**REMEDIATION SYSTEM EVALUATION**

**OCONOMOWOC ELECTROPLATING SUPERFUND SITE**  
**ASHIPPUN, WISCONSIN**

Report of the Remediation System Evaluation,  
Site Visit Conducted at the Oconomowoc Site  
14-15 March, 2000

Final Report Submitted To Region 5  
August, 2000  
(Reformatted, January 24, 2001)

Figure 4-1. Observed concentrations, MW-05D

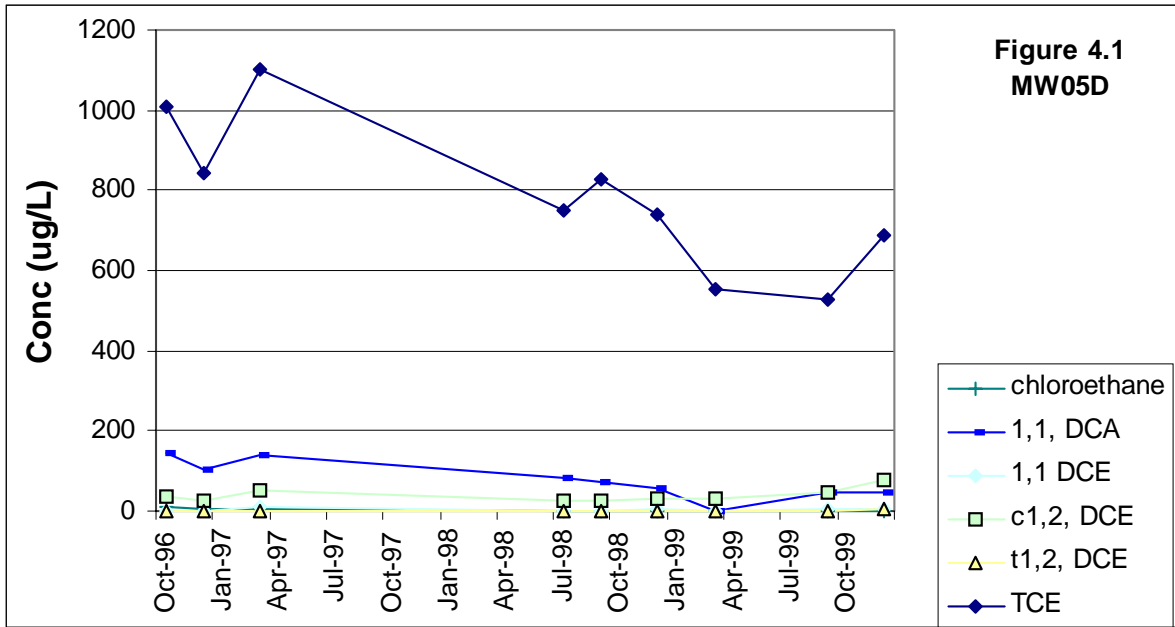
Ground water samples are currently obtained from monitoring wells MW02D, MW05D, MW06S, MW12B, MW12D, MW14D, MW15D, and MW16D. If not dry, samples are also obtained from MW03S and MW05S. Although hydropunch sampling done during the pre-design investigation indicated the limits of the plume, the plume is not well defined by the current monitoring system. The primary concern appears to be chlorinated organics in ground water. The extent of the organics plume is not clearly defined east of EW-3, MW05D, and EW-5, and is also not clearly defined west of MW15D (within a residential neighborhood where wells are used for water supply). Levels of TCE in MW15D, which is screened within the shallow aquifer, have consistently measured near 30 ug/L in this residential area. Residential wells are screened in the deeper bedrock aquifer, and detections of TCE of approximately 0.5 ug/l at these residential wells were mentioned during the site visit. Monitoring well MW05D has consistently shown levels of a number of organics, particularly TCE, above the PALs. Although concentrations in MW15D have been quite stable, there is evidence for decreasing concentrations of TCE and 1,1 dichloroethane in MW05D as shown in Figure 4-1.

Figure 4-2. Observed concentrations, MW-12D.

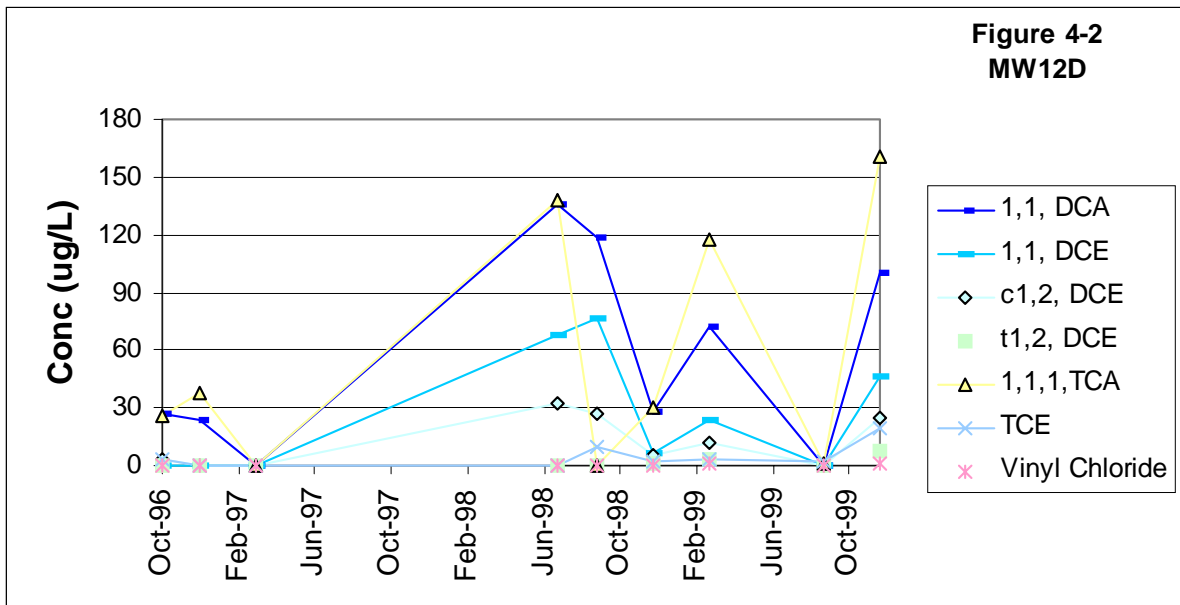
Based on the observed high concentrations of copper in well MW12D, recommend that surface water samples be collected near MW12D, if filtered samples suggest the copper to be dissolved, to determine if copper concentrations in ground water may cause elevated levels in surface water. Costs for conducting the surface water sampling and analysis would be less than \$300.
